ASHRAE ADDENDA

Method of Test for Conformance to BACnet[®]

Addendum 135.1*e* to ANSI/ASHRAE Standard 135.1-2009 contains a number of changes to the current standard. These modifications are the result of change proposals made pursuant to the ASHRAE continuous maintenance procedures and of deliberations within Standing Standard Project Committee 135. The changes are summarized below.

135.1-2009e-1. Revise BACnet/IP tests.

Figure 14-1. Logical network configuration for BBMD tests.

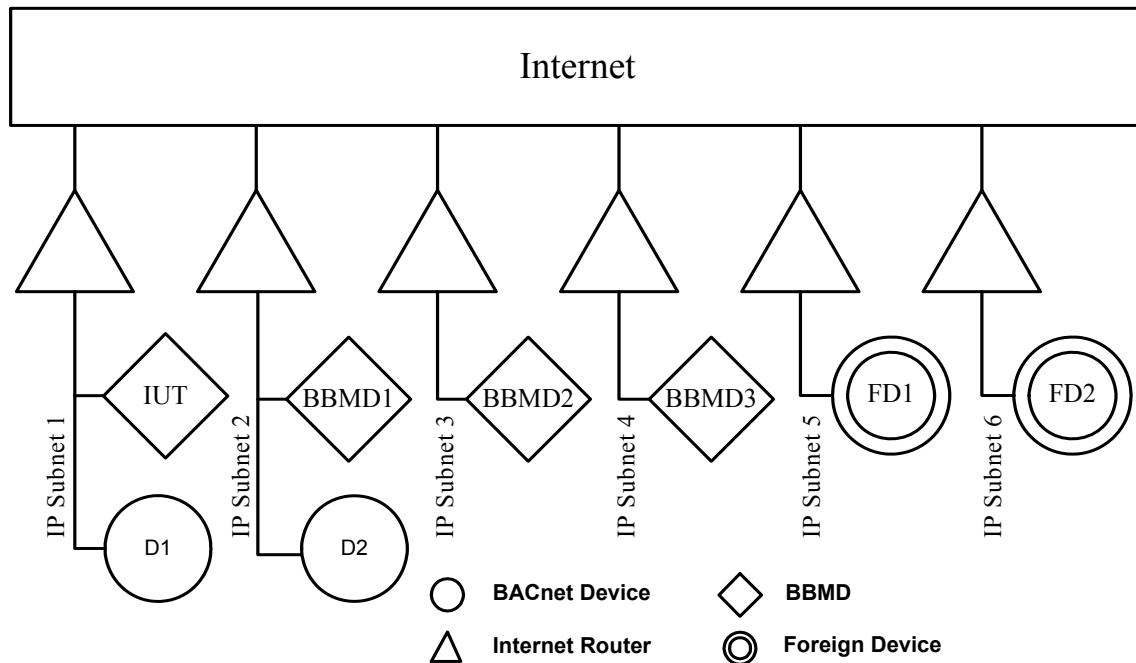
[Reason for Change: Originally these tests were for non-BBMD Devices. It was recognized that a test for a BBMD device with a server application was also needed, so these tests were expanded to include both non-BBMD devices and BBMD devices. Because the non-BBMD tests in this section duplicate the tests 14.1.7, 14.1.8, and 14.1.9, they were removed from this section. This resulted in these tests being exclusively for BBMD devices. BBMD tests were modified to reference Figure 14-1. This was done to enable the tester to choose IP address and subnet mask settings as appropriate and to clarify the role of the TD in each test.]

Notes to Tester: Figure 14-1 shows the logical network configuration for tests 14.2 – 14.7. The complete network is not required for the tests, so long as the IUT can receive packets formed as though they arrived from the specified device. The role of the TD when executing the TRANSMIT statement in each test is specified. The TD must also monitor the IUT's subnet throughout all tests and RECEIVE shall mean from the IUT's subnet. To accomplish this, the TD may be multi-homed or another TD can be used to monitor the IUT's subnet.
